# Minor Design Changes

In contrast to the larger alignment change that is needed at the ash basins, several smaller changes have been made in other specific locations. These changes are the results of efforts to optimize the design that was proposed during preliminary engineering.

Acid Rock Focus Area

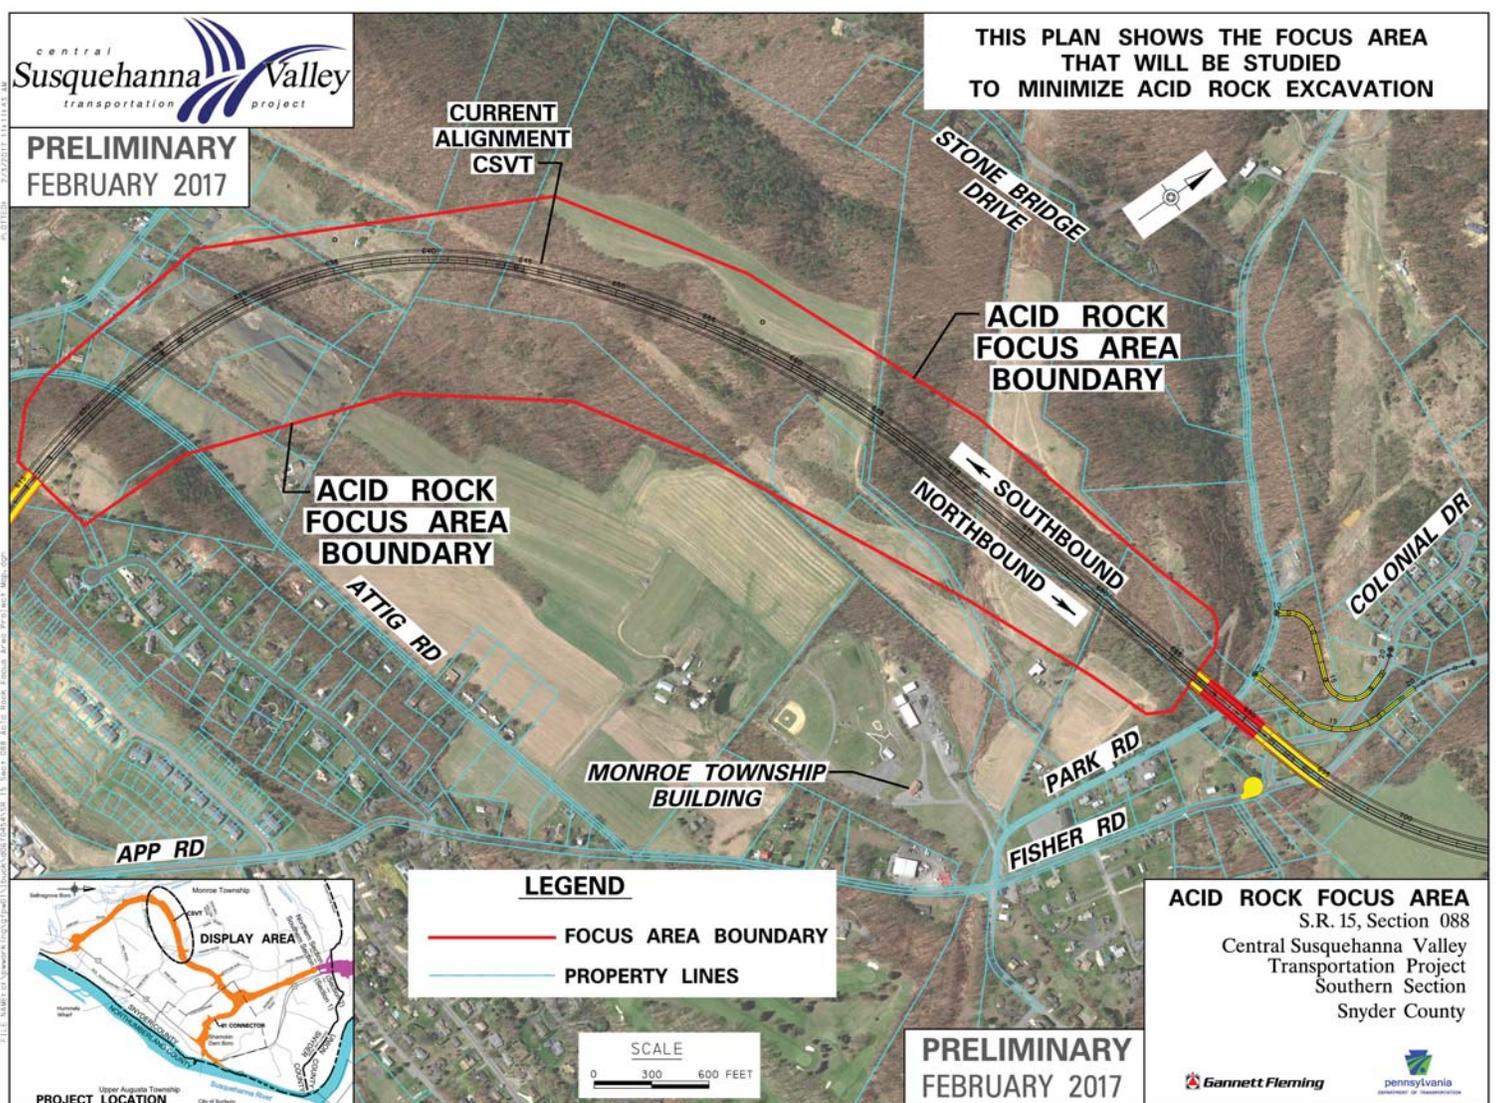
Geotechnical studies performed in 2016 revealed that there is acid bearing rock along the proposed CSVT alignment between Attig Road and Park Road. There is also a very small area of acid rock just south of Attig Road. Acid bearing rock contains iron sulfide. It can produce acid at a quick rate when it is excavated into smaller pieces and exposed to air and water, potentially causing environmental issues similar to acid mine drainage. While it is an unexpected development on CSVT, acid rock is straightforward to address.

The project team has coordinated with PADEP and developed a plan to address the acid rock challenge. The plan includes minimizing excavation of acid bearing rock, diverting stormwater around acid rock areas, and treating the excavated rock and stormwater runoff. In order to minimize excavation, the project team will look at shifting CSVT within an acid rock focus area between Attig Road and Park Road. The red line in the figure below shows the limits of the possible alignment adjustments.

US 522 and US 11/15 Corridor

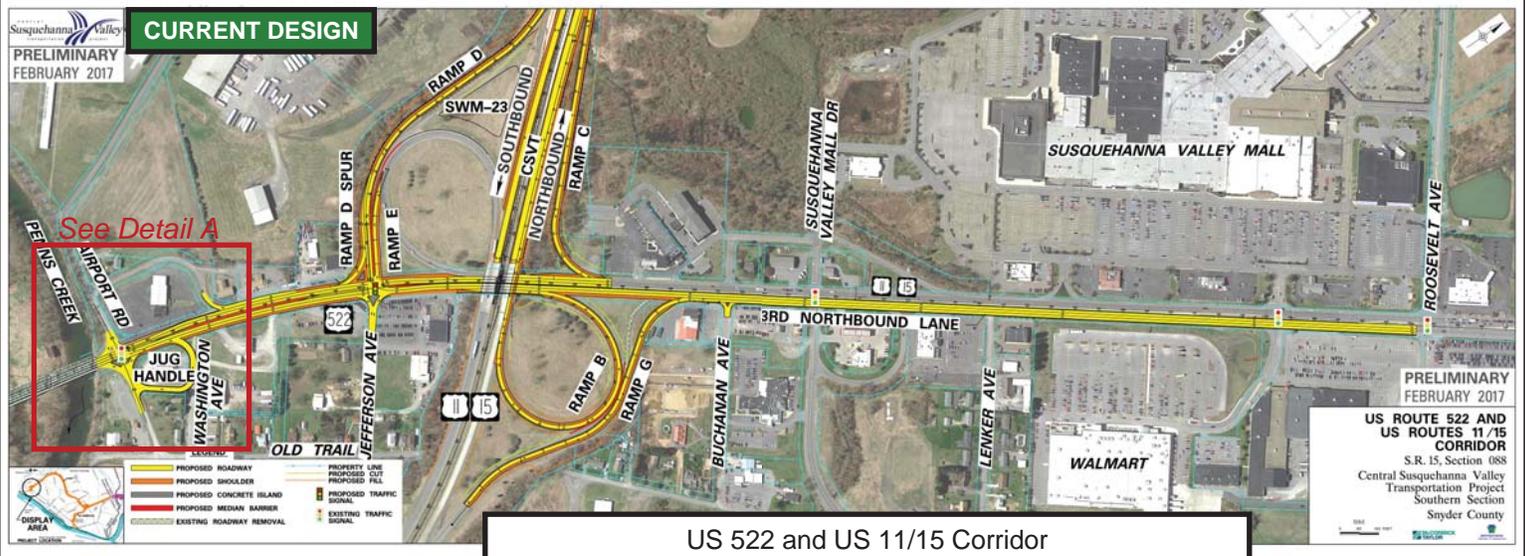
At the interchange of CSVT, US 522 and US 11/15, ramps have been reconfigured to improve geometry and operations. Most notably, the existing northbound off ramp geometry has been improved to flatten the curve as the ramp merges with US 11/15 northbound. Two northbound US 522 lanes are needed through the interchange to accommodate projected future traffic volumes. Therefore, a third lane on US 11/15 northbound has been added to the design, extending from the interchange to Roosevelt Avenue.

Detail A - US 522 / Airport Rd Intersection

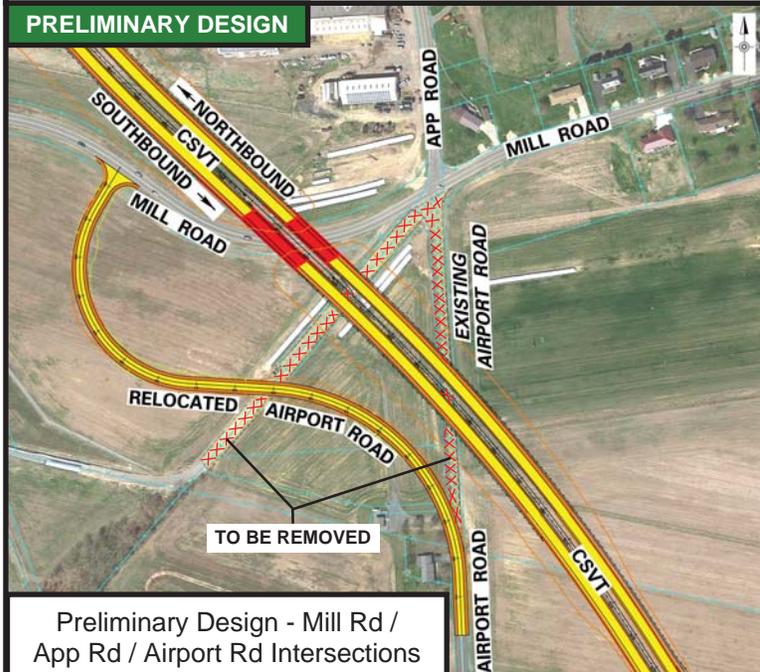
To ensure efficient traffic flow in the future, the existing two lane section of US 522 southbound will be extended from the interchange through the Airport Road intersection and carried across the existing truss bridge over Penns Creek toward Selinsgrove.

The existing US 522 northbound left turn lane to Airport Road will be removed and replaced with a jug handle at Washington Avenue. Northbound US 522 motorists who wish to turn left onto Airport Road will proceed straight through the signalized intersection and then turn right onto the jug handle at Washington Avenue. At the end of the jug handle, motorists will turn right onto Airport Road and proceed straight through the intersection.

Current Design - Mill Rd / App Rd / Airport Rd Roundabouts

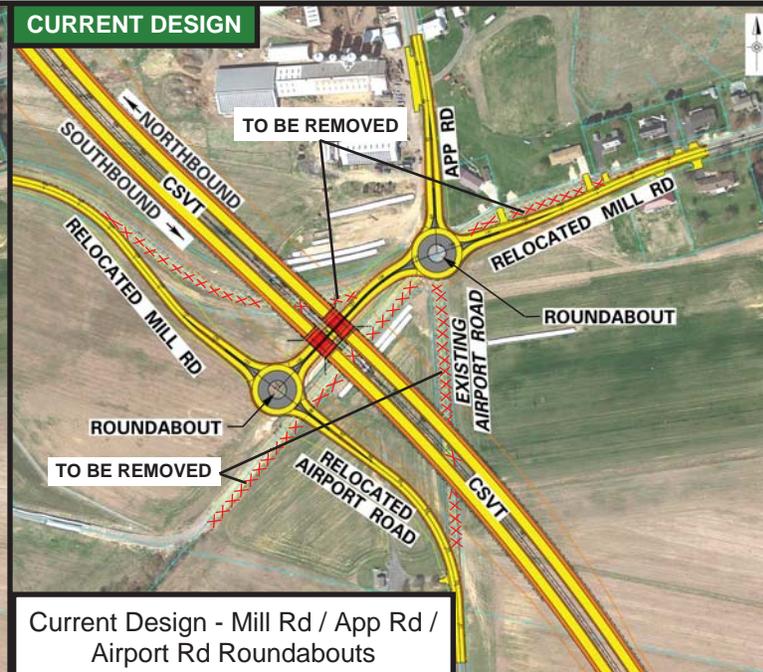
The preliminary design (shown above on left) included two “T” intersections. Airport Road was relocated to intersect with Mill Road at a “T”. App Road and Mill Road formed another “T” intersection. This design raised safety concerns related to intersection sight distance. It also required more complicated bridges to be constructed due to the angle between CSVT above and Mill Road below.

The design of the Mill Road / App Road / Airport Road area has been modified to include two roundabouts. One roundabout will serve the intersection of Mill Road and App Road and the other will serve the intersection of Mill Road and Airport Road. The modification improves intersection sight distance and safety and accommodates future traffic growth. Additionally, it simplifies the construction of the CSVT bridges over Mill Road.

Current Design - Park Rd and Fisher Rd Crossing

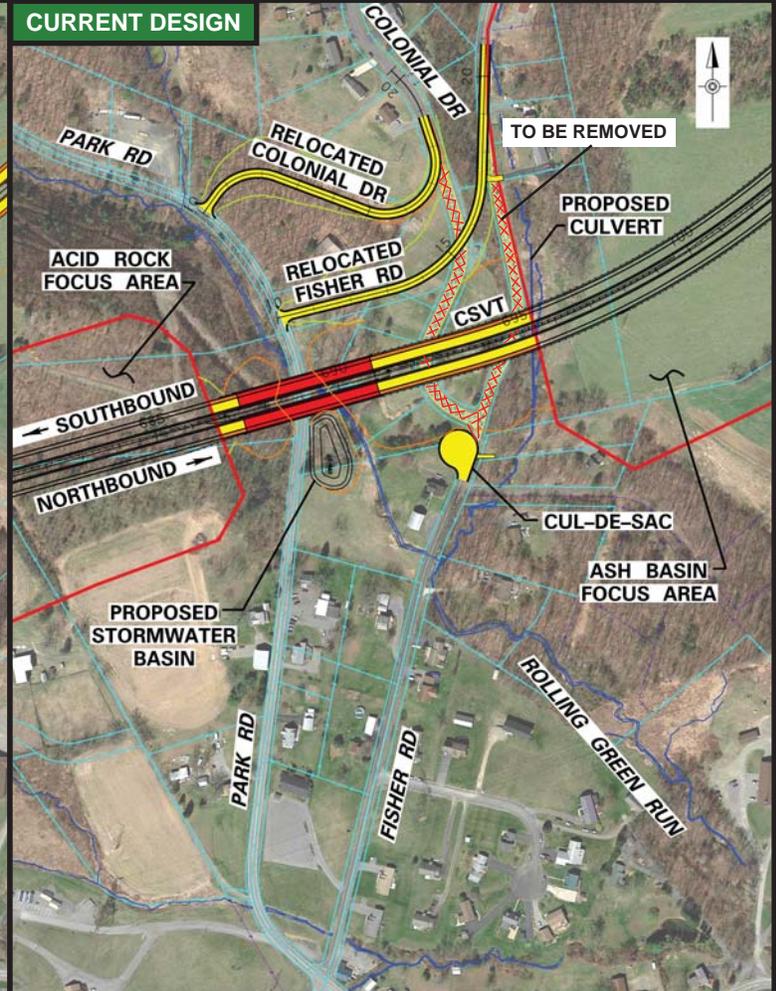
The preliminary design in the Colonial Acres area called for two sets of bridges to be constructed back-to-back to carry CSVT over Park Road and Fisher Road. The design also called for Colonial Drive to be realigned to form a "T" intersection with Park Road.

Construction of back-to-back bridges would be difficult, requiring large temporary ramps to place the fill between the bridges. These temporary ramps would greatly increase the footprint and impacts of the project. Therefore, one set of three-span bridges will be constructed to carry CSVT over Park Road and Rolling Green Run. Fisher Road will be realigned to run parallel to CSVT and tie into Park Road just north of the new CSVT bridges. The southern portion of Colonial Drive will be realigned to intersect Park Road approximately 340 feet north of the new Park Road / Fisher Road Intersection. A cul-de-sac will be constructed at the end of the short portion of existing Fisher Road that will remain south of CSVT.

While the current design has eliminated the bridges carrying CSVT over Fisher Road, this design change should not be considered a closure of Fisher Road. Instead, the change simply shifts the intersection of Park Road and Fisher Road roughly 1/3 of a mile to the north, from one side of CSVT to the other. This reconfiguration of the local roads will not negatively impact traffic flow through the Colonial Acres area. The project team is currently working with Monroe Township to finalize the design at this location.

Current Design - PA 61 & US 11/15 Interchange

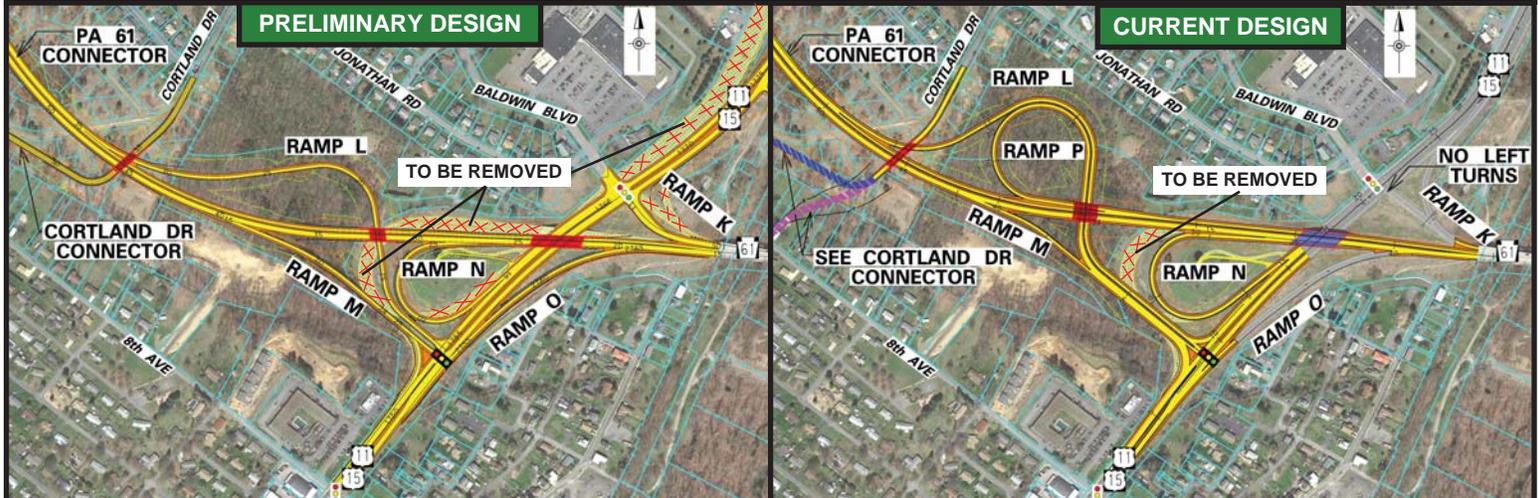
This interchange has been modified to allow traffic to move more efficiently along US 11/15. The interchange has been changed to a full trumpet-style design to provide a more free-flowing movement for PA 61 northbound traffic from Sunbury exiting to US 11/15 southbound. With the preliminary design (shown above on left), this movement was served by exiting onto Ramp K at the end of the Veterans Memorial Bridge and then turning left at the signal at the bottom of the ramp. With the current design (shown above on right), the movement is served by continuing on the PA 61 Connector over US 11/15 and exiting onto a new loop ramp, Ramp P. At the end of the new ramp, traffic can turn right onto US 11/15 southbound.

US 11/15 Split

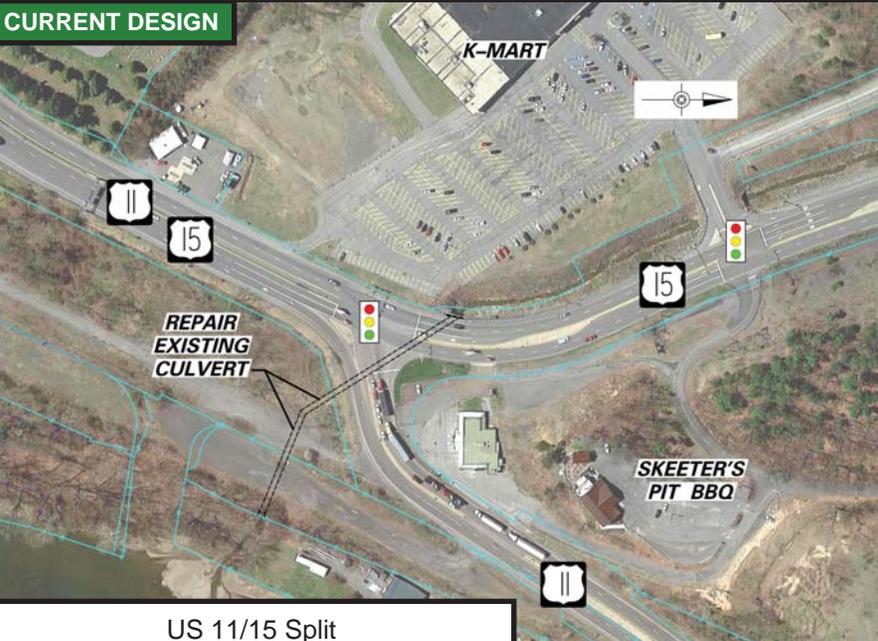
Analyses of traffic operations at the US 11/15 Split show that the intersection functions efficiently now and in the future after CSVT is open to traffic.

Therefore, the previously proposed reconfiguration of the intersection has been eliminated. After CSVT opens, PennDOT will evaluate the new traffic patterns in the area to determine if changes are required.

Since the previously proposed reconfiguration would have shifted US 11/15 substantially closer to the river, this change provides the benefit of not precluding potential development of the riverfront.

Cortland Drive Connector

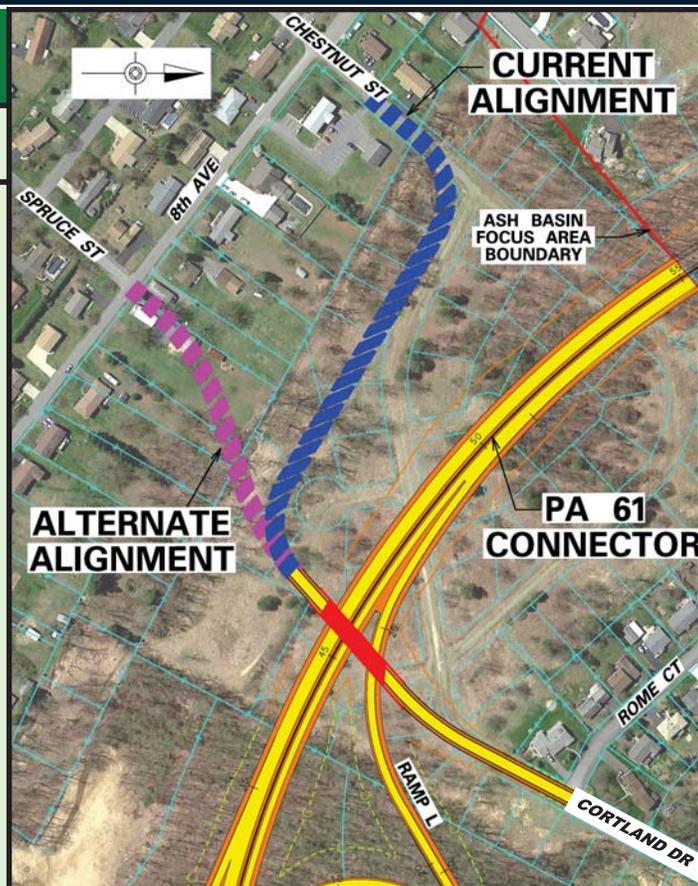
Cortland Drive will be extended from its current endpoint, bridging over the PA 61 Connector to connect Orchard Hills to the Gunter development. Two options are being considered for this connection:

- Current Alignment – As approved in the Final Environmental Impact Statement for CSVT, Cortland Drive would be extended from its current endpoint to connect with Chestnut Street.
- Alternate Alignment – As requested by Shamokin Dam Borough, Cortland Drive would be extended from its current endpoint to connect with Spruce Street.
